Docket: NRC-2014-0163
Issuance of Draft Regulatory Guide

Comment On: NRC-2014-0163-0001
Setpoints for Safety-Related Instrumentation; Issuance of Draft Regulatory Guide for Comment

Document: NRC-2014-0163-DRAFT-0003
Comment on FR Doc # 2014-16165

**Figure 1: CANDU 6 Steam Generator Level
Reactor Power Diagram**

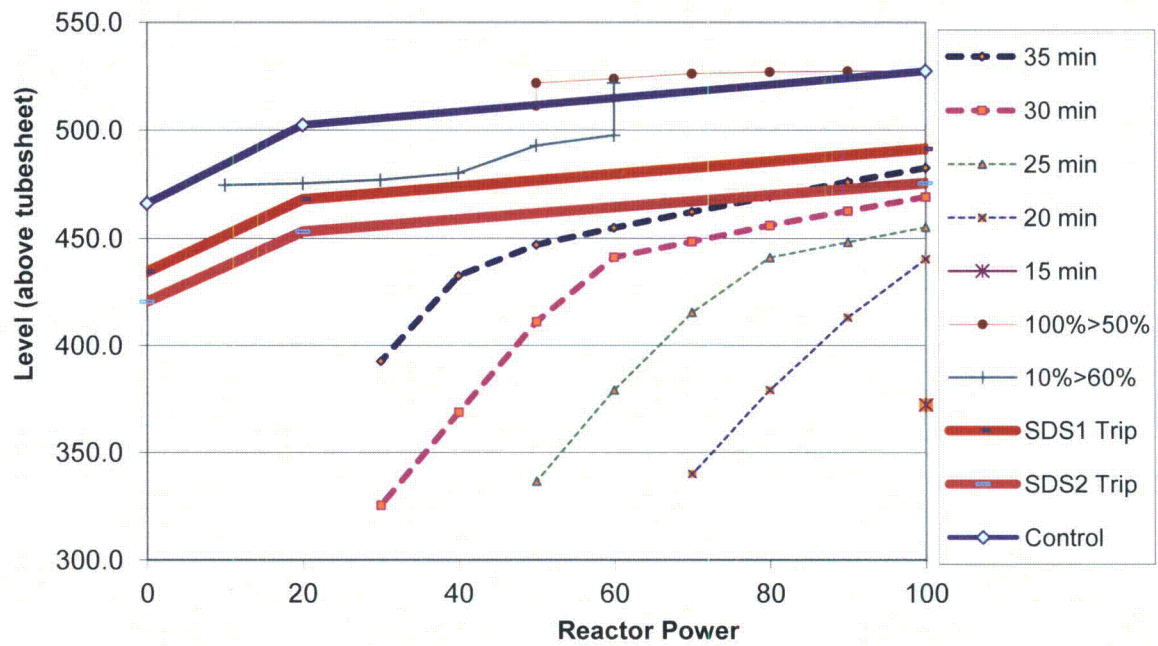
TSP_{SG} for SDS1 and SDS2 should follow the 35/30 min dashed lines ($f_c[RP]$) not the solid control ramp as now in Figure 1.
